1.1 PROJECT – H59-6213-ML

UPGRADE AND REPLACE MULTIPLE HVAC UNITS – CONWAY CAMPUS

ADDENDUM NO. 1

September 13, 2023

3 GROUNDING DETAIL  
E101 NOT TO SCALE

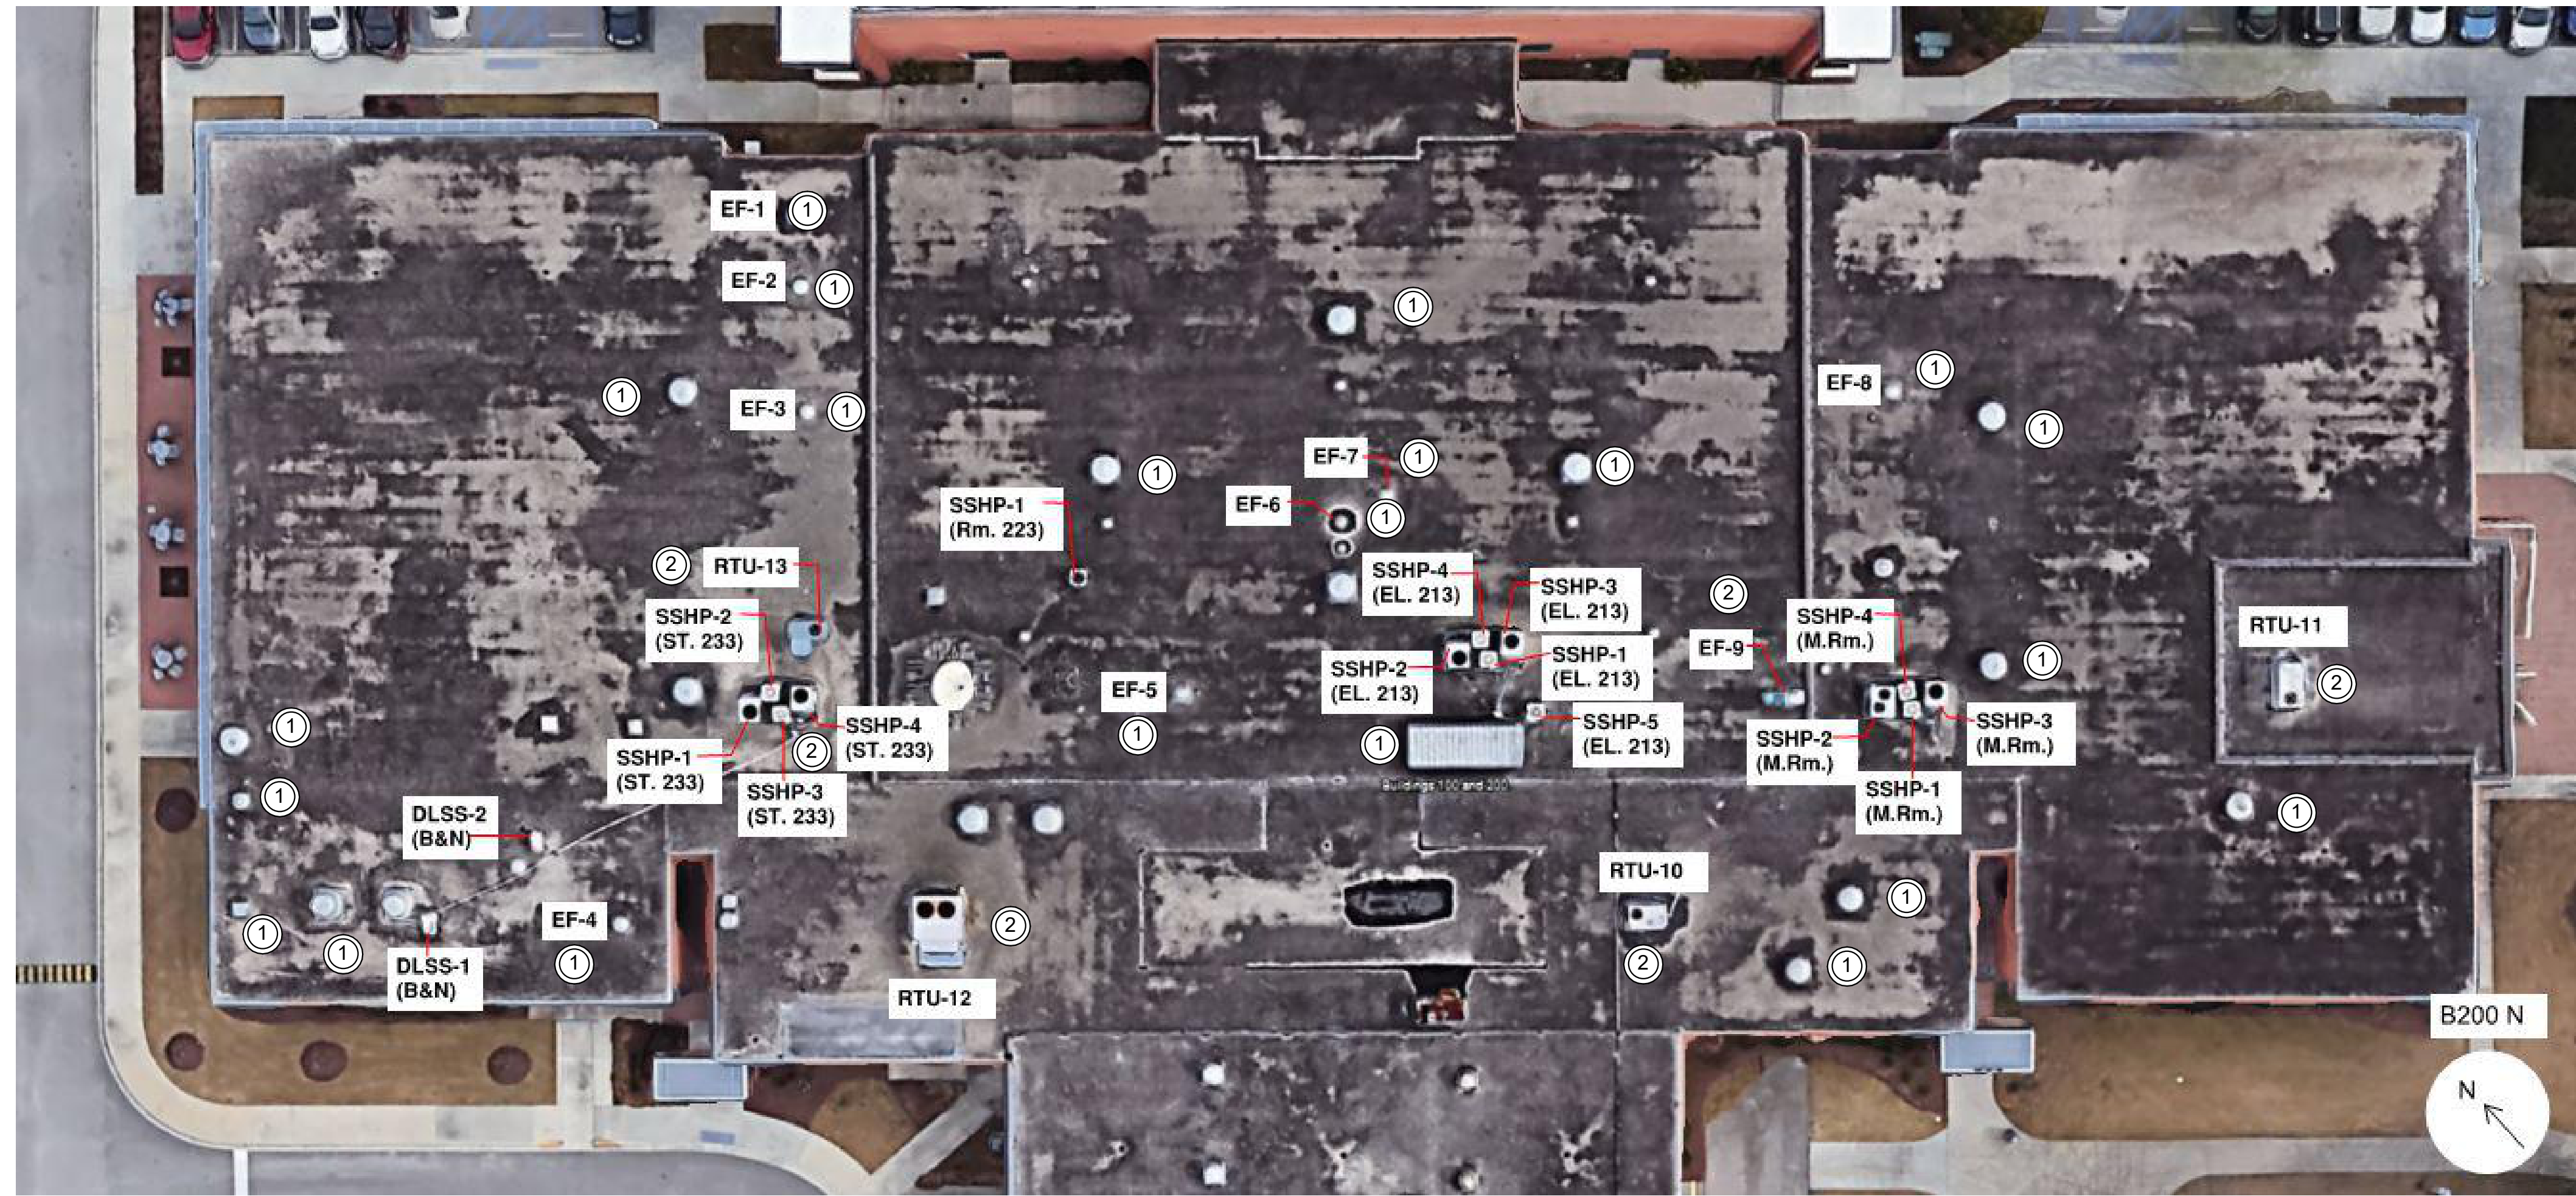
- A. The pre-bid conference held September 6<sup>th</sup> was not mandatory.
- B. The following changes/clarifications shall be made to the drawings. Revised drawings are attached.
1. E101
    - a. Grounding Detail Added
    - b. General Fire Alarm System Notes added.
  2. E102
    - a. Electrical Requirements for DLSS-1,2 Outdoor Units modified.
    - b. Electrical Requirements for DLSS-1,2 Indoor Units modified.
    - c. Note 3 on the Equipment Connection Schedule was added.
  3. M002
    - a. Detail 6 was revised – use copper for condensate drains piping.
    - b. Detail 2 was revised – smoke detector not required on supply duct.
    - c. Detail 9 was revised – use copper for condensate drain piping.

3 ROOF TOP UNIT INSTALLATION DETAIL  
SCALE: NOT TO SCALE

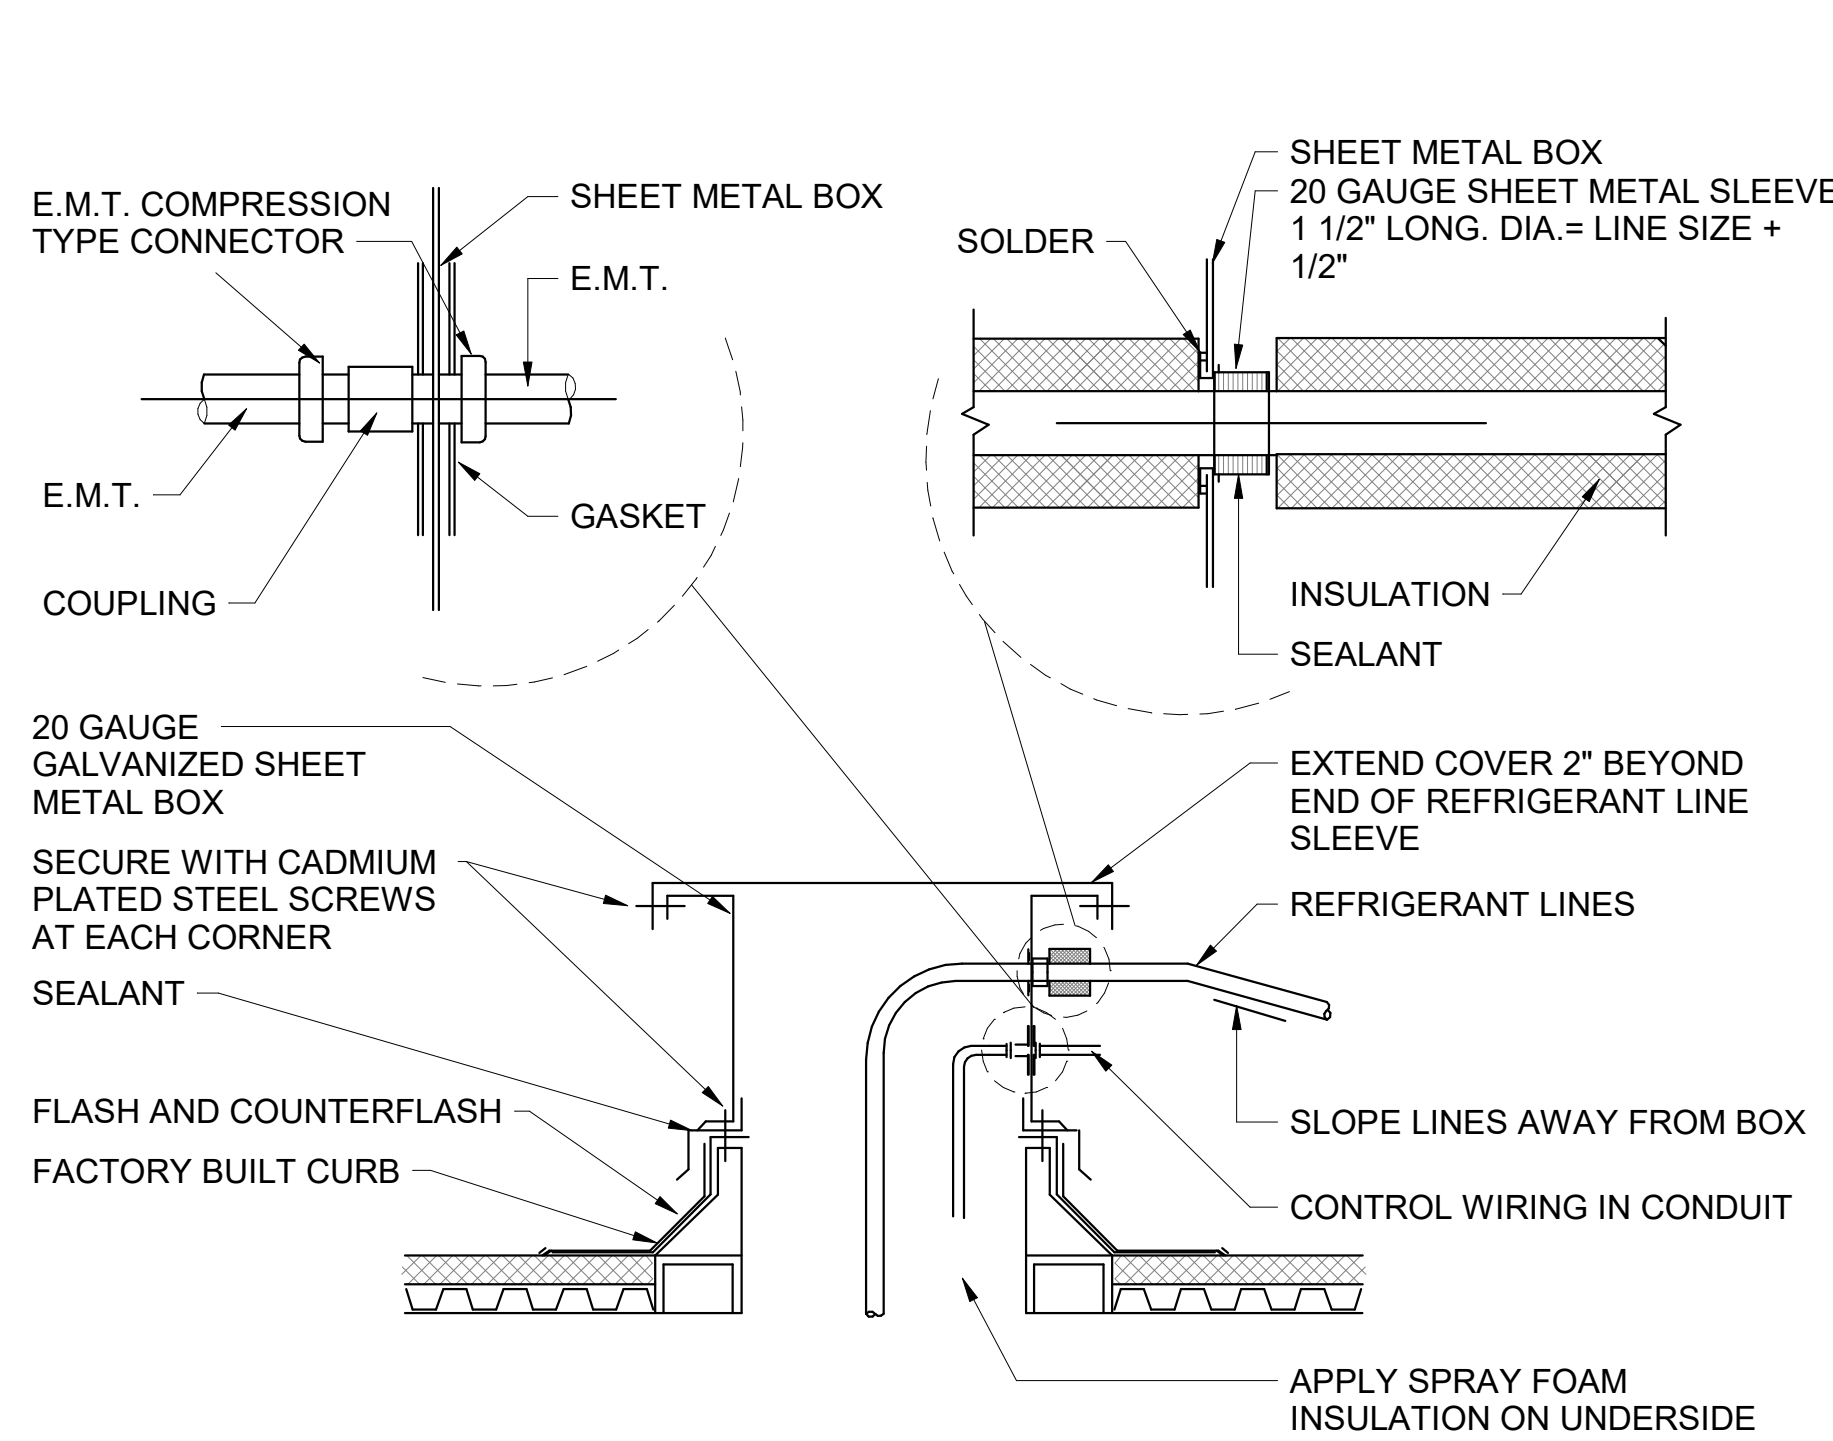
- d. Detail 3 was revised – smoke detector not required on supply duct. Clarification of curb requirements.
  - e. Detail 4 moved to drawing M102.
  - f. Detail 8 was revised.

See detail 3 on drawing M002 for auxiliary steel support requirement between bar joists around perimeter of new curb. Size of auxiliary steel support will be part of the seismic curb submittal.

4 MECHANICAL PIPE SUPPORT DETAIL  
SCALE: NOT TO SCALE

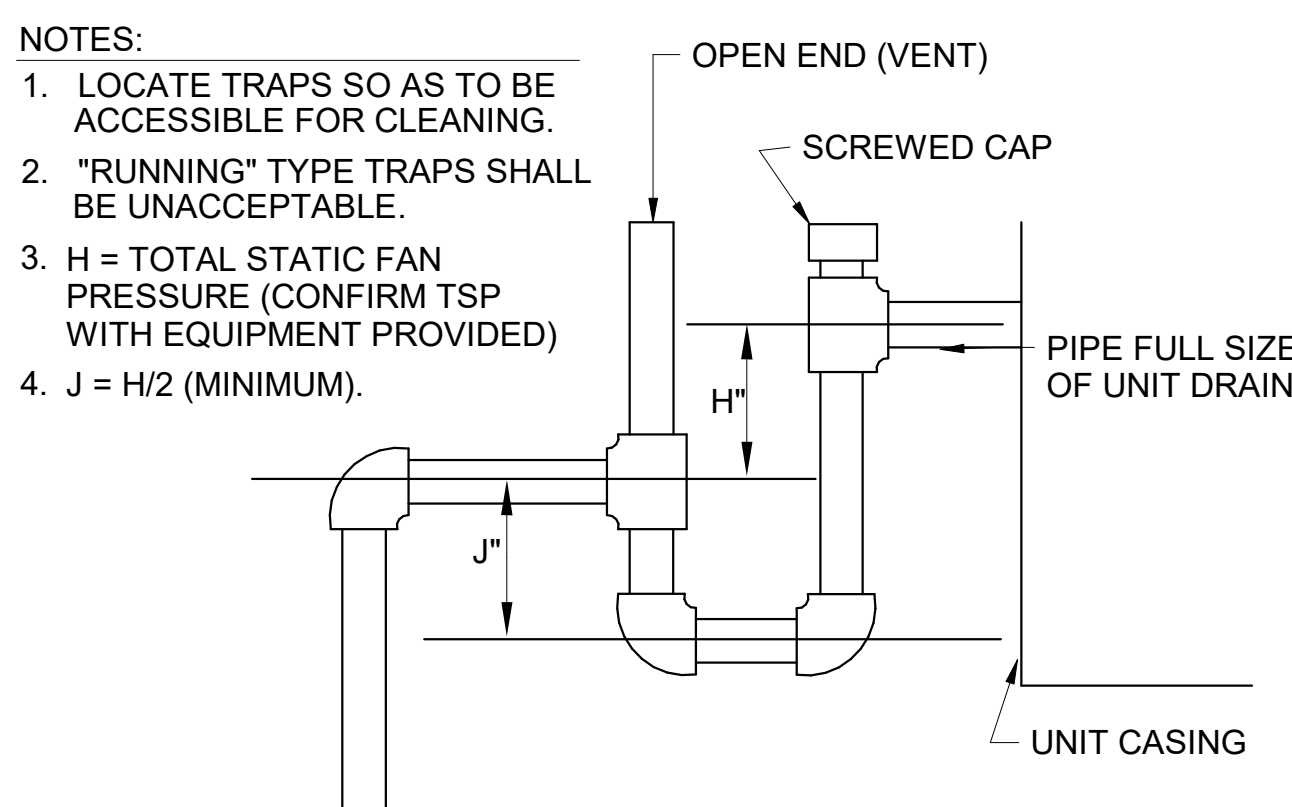
- g. Mechanical pipe support detail added.
- 4. M101
    - a. Mechanical schedule revised – added supply air, static pressure, and outside air requirements along with additional unit specifications.

10 ROOF RAIL DETAIL  
 M102A SCALE: NOT TO SCALE

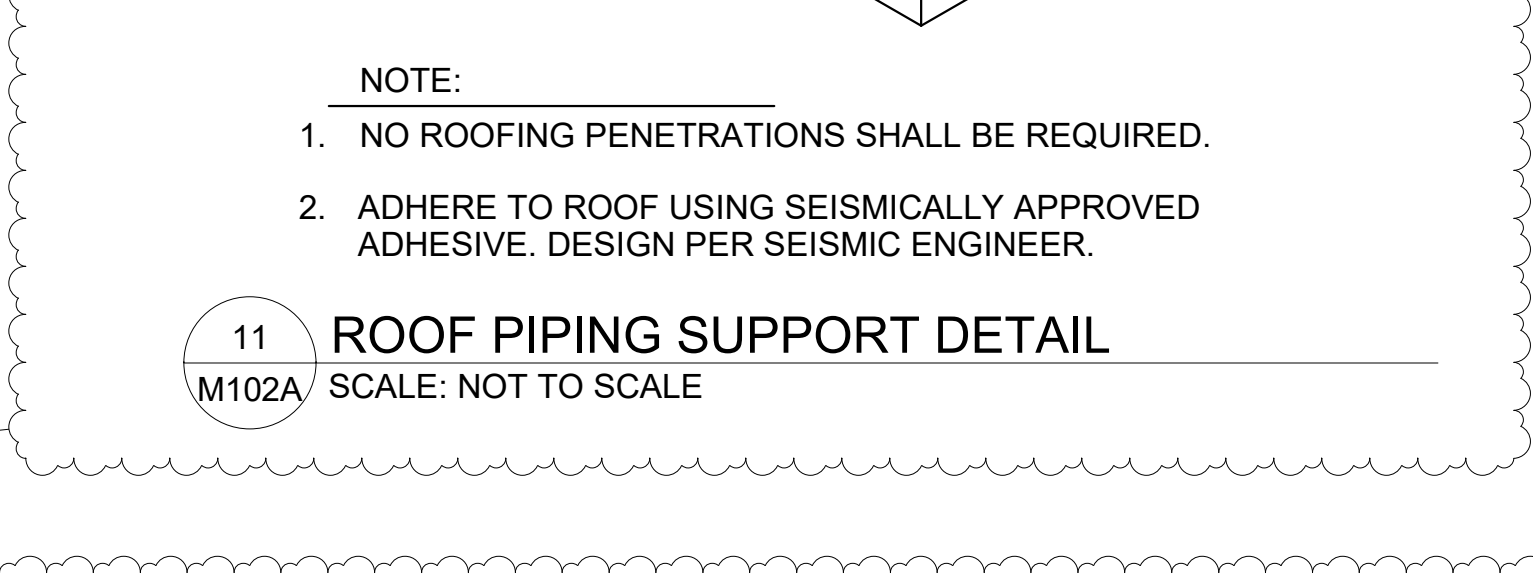
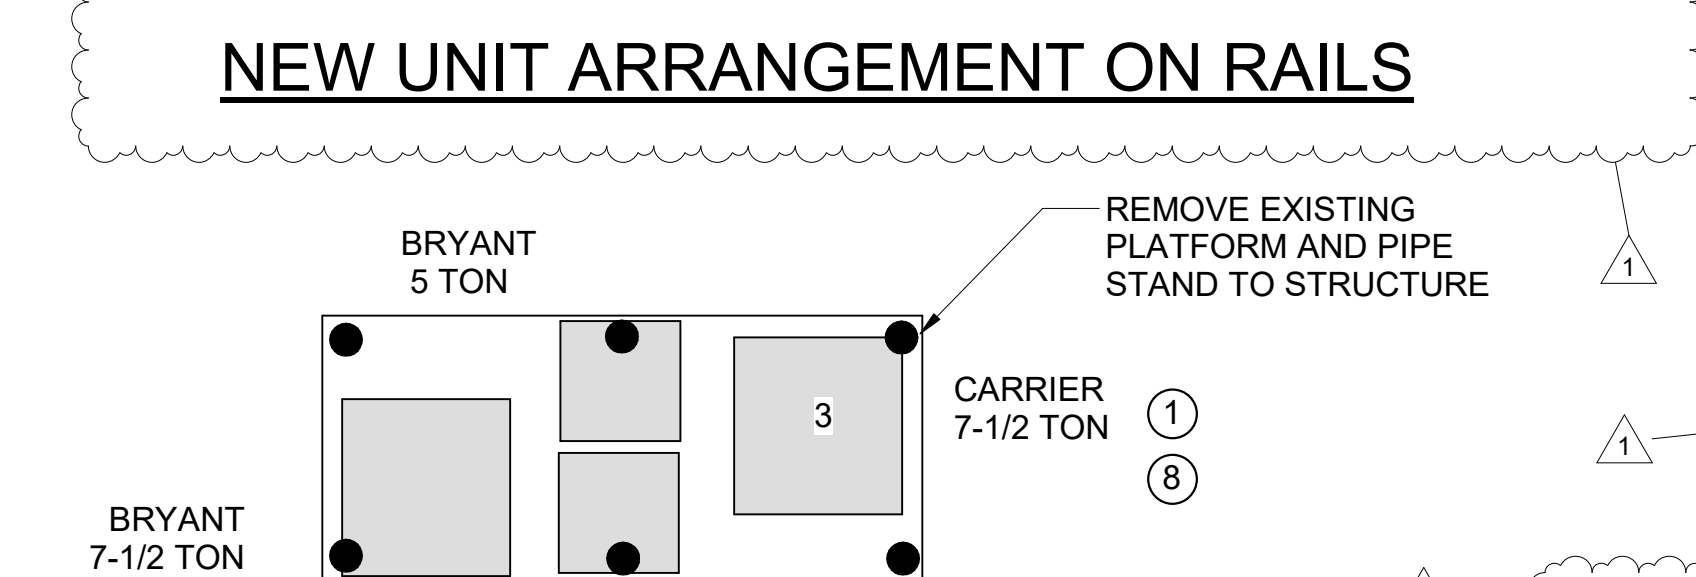
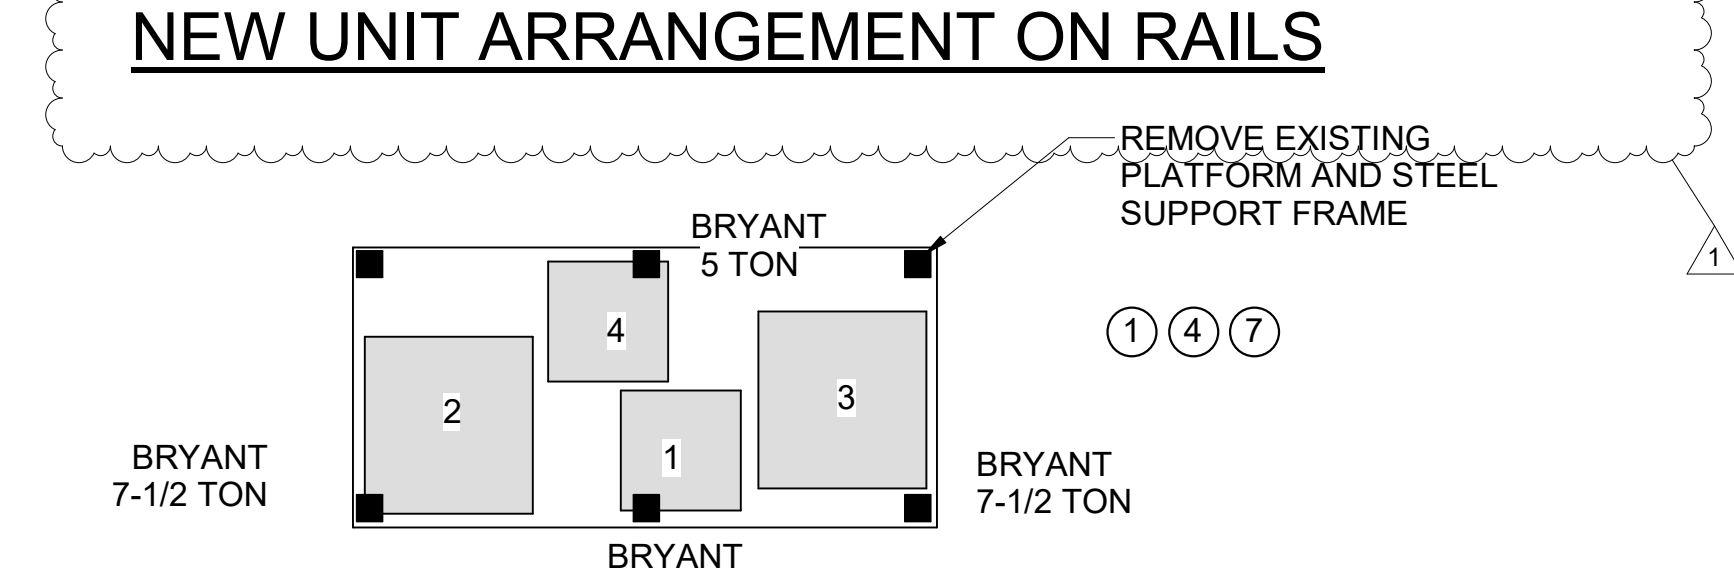
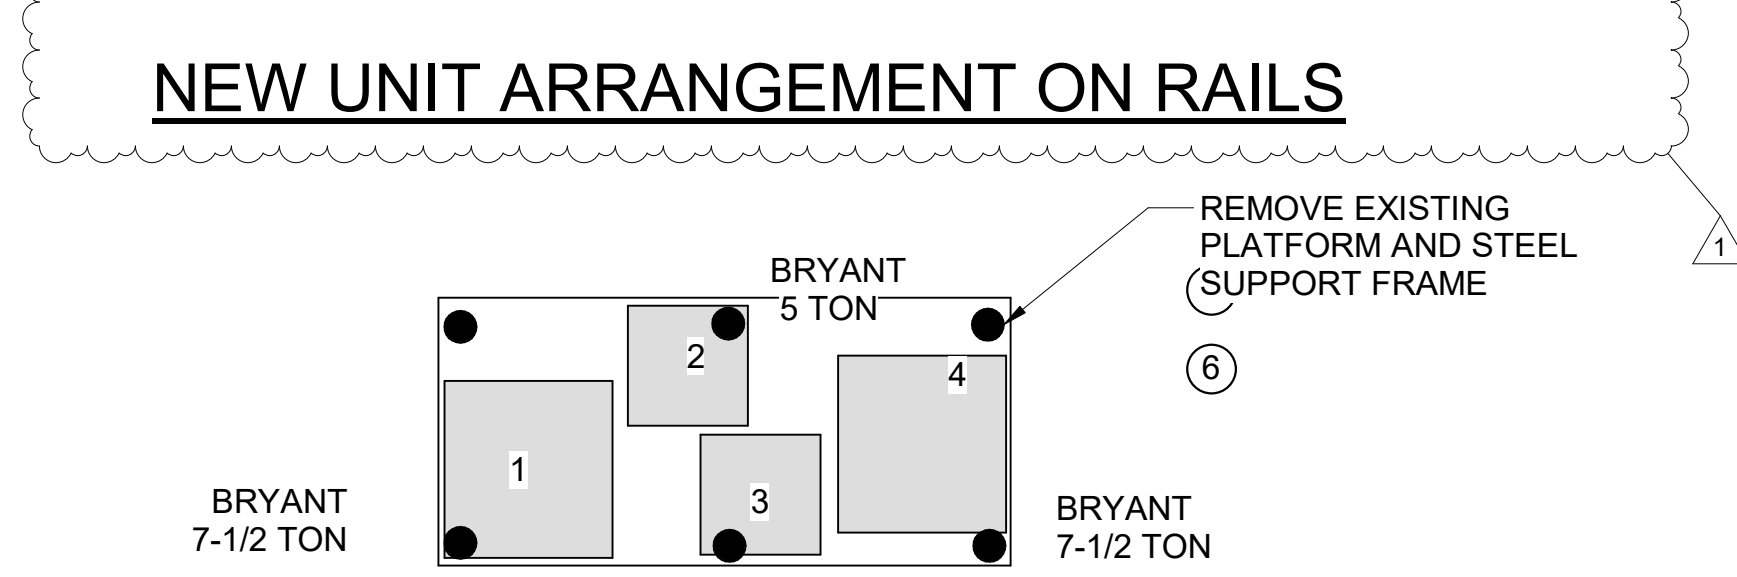
- b. Details 3, 4, and 5 have been modified to eliminate platforms. See new detail for mounting outdoor units on rails.
    - c. Detail added for roof piping support.
